**Project: IEEE P802.15 Working Group for Wireless Personal Area Networks  
(WPANs)**

**Submission Title:** assigned comments for draft D2

**Date Submitted:** September 2010

Split Figure 23 into Figure 23 (a) and Figure 23 (b)

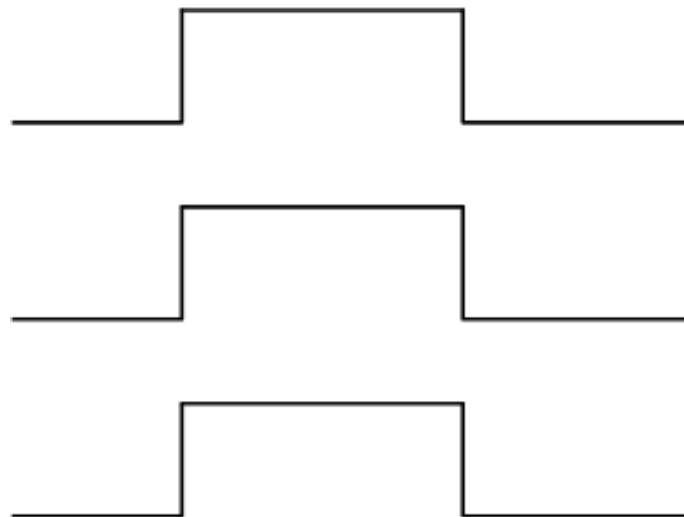
Accepted in principle. Three action items here (assigned to Sridhar) ...

1. Split option field into 4 fields for OOK and 1 CES field for PHY III

2. Answer the question "does dimmed OOK apply to PHY III

3. Clarify text to indicate that the CES option field is turned on by reading the MCS ID.

Add following text on Pg 37, line 16

- The options field in Figure 23 (a) shall be transmitted only if the dimmed OOK bit is set in the PHR.
- The options field in Figure 23 (b) shall be transmitted only if PHY III is selected based on the MCS ID chosen in the PHR.
- The dimmed OOK mode shall not be used with PHY III. i.e. both the option fields shall never be used simultaneously.

(a) Output from PHY SAP

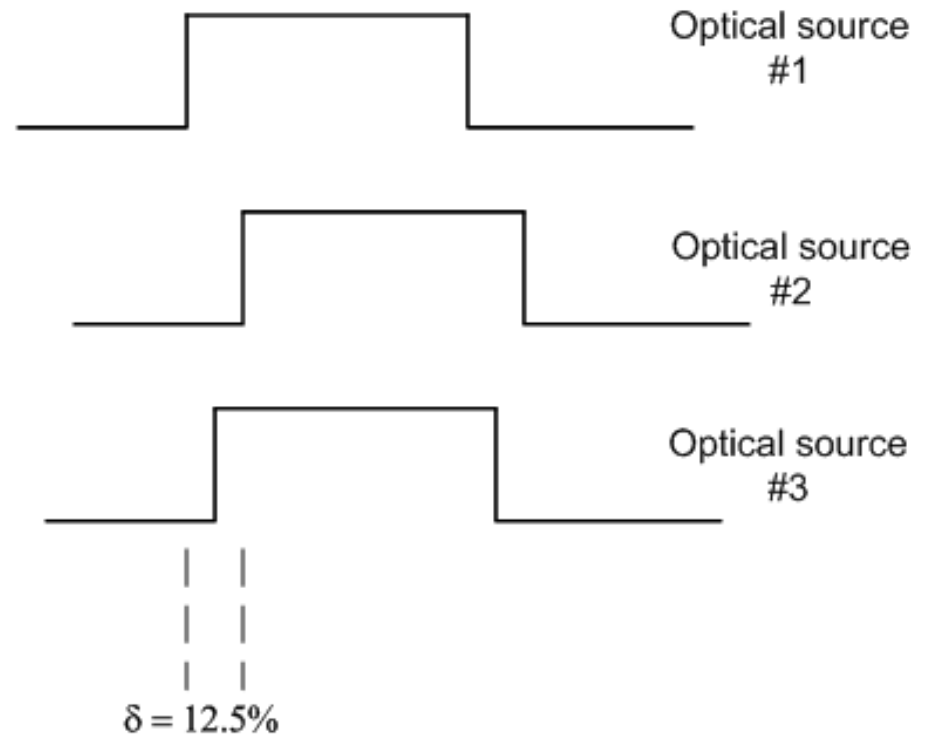
In the receiver side, ADC for PHY III should have at least 4 over times sampling rate to symbol rate.

For avoiding the degradation, the delay difference should be smaller than a half of the sampling period.

As a result, the allowable delay difference is  $1/8$  of the symbol duration. So,  $\Delta$  should be less than 12.5% of symbol clock.

Add subclause 5.1.x for “Maximum error tolerance for multiple optical sources”

Suggested text:

- If multiple optical sources are used, it is recommended the optical sources have similar frequency responses in order to assist communication. The input to all the optical sources from the PHY shall be synchronized. The error at the output of the optical sources shall not vary by more than 12.5%
- Add figure (optional – per committee decision)
